**AG-SB-2017-03-B-EN – MT03 control rod**

**Category B**

05.05.2017

**Fig. 1: old control rod with diagonally cut**

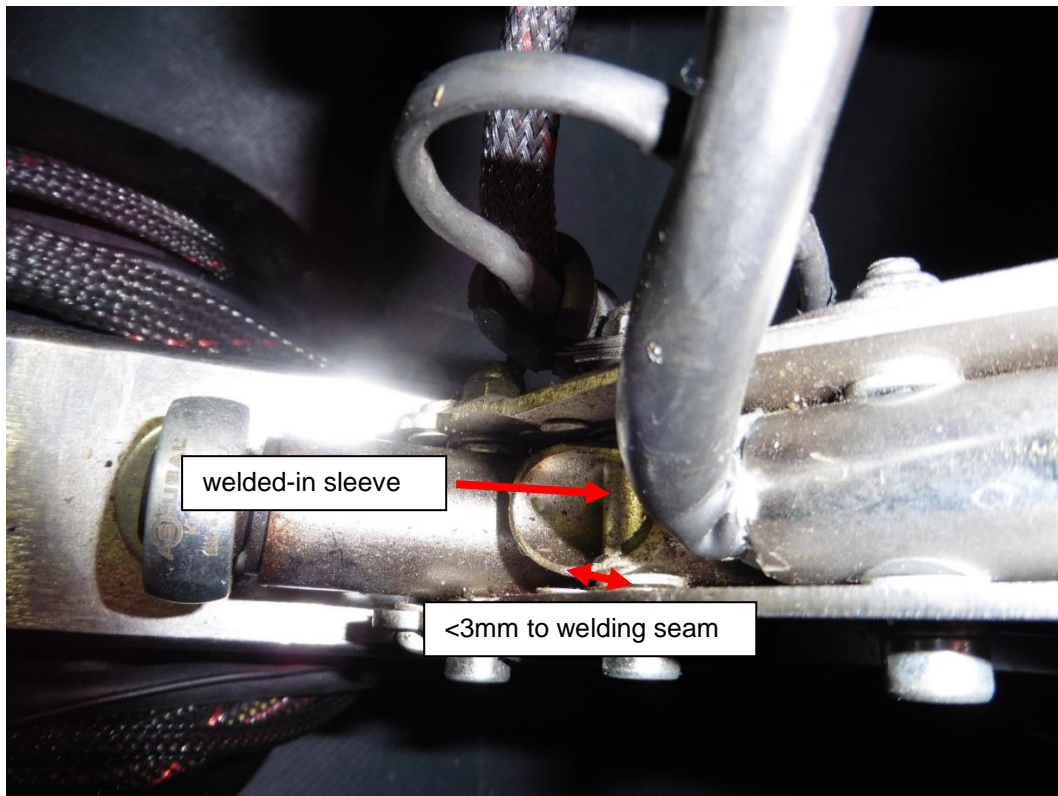
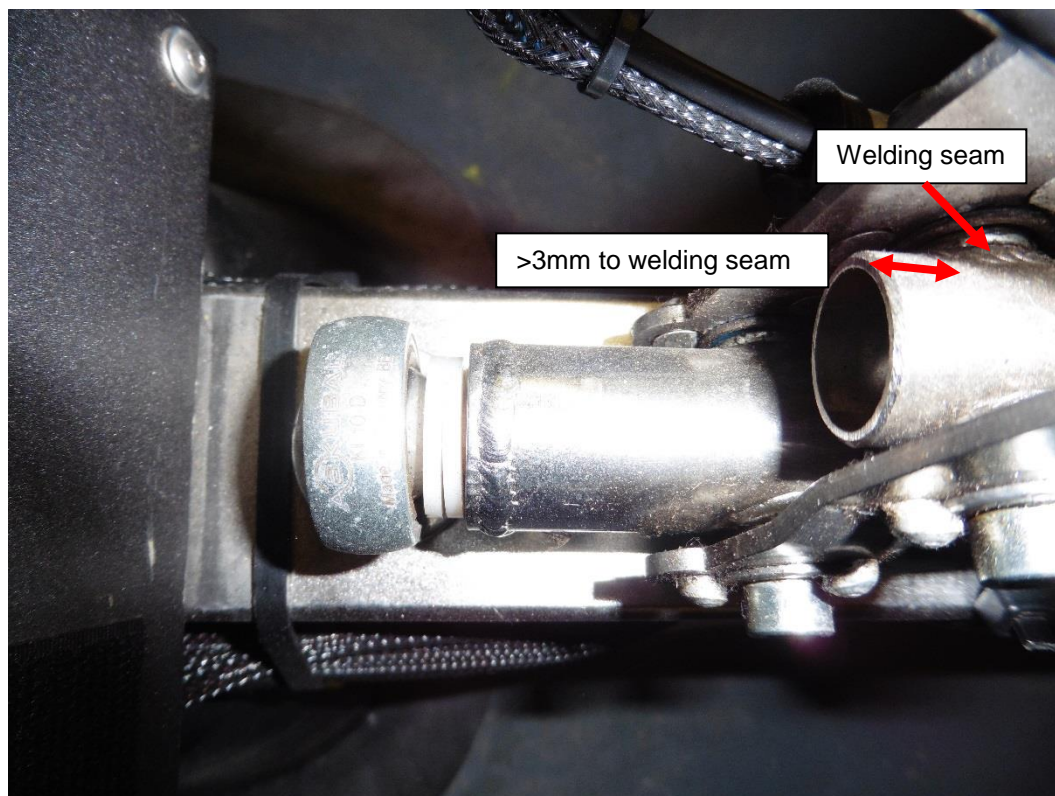
This Service Bulletin is applicable for all MT03 and converted MT03 to MTOsport until 12 / 2007, where the control rod is cut diagonally (see fig.1).

A case was found with a failed weld and subsequent tube failure at the upper control rod joint to the front control stick. Normally this would be found during maintenance or pre-flight inspection, so the purpose of this SB is to highlight the need to check this part.

Additionally, the check provides an opportunity to replace the existing tube with a later generation improved part should the original fall outside of the recommended dimensions.

- Inspect that the welded-in sleeve inside the end of the tube is secure, and no evidence of weld failure.
- Inspect if the control rod has been cut down more than 3mm between the end of the rod and the outer wall of the welding seam.
- Rectification: replace the control rod if cut down limit of 3mm is exceeded.

- 1 Remove the attachment bolt between the tube and the side plates to the stick.
- 2 Inspect that the welded-in sleeve inside the end of the tube is secure, and no evidence of weld failure.
- 3 Inspect if the control rod has been cut down more than 3mm between the end of the rod and the outer wall of the welding seam.
- 4 Rectification: If the cut down limit of 3mm is exceeded, remove the control rod (camshaft) and replace with a new control rod in line with the MMM. Contact AutoGyro service to obtain a matching part.
- 5 If the control is acceptable for continued service, refit the bolt with a new nylock nut as per the MMM.
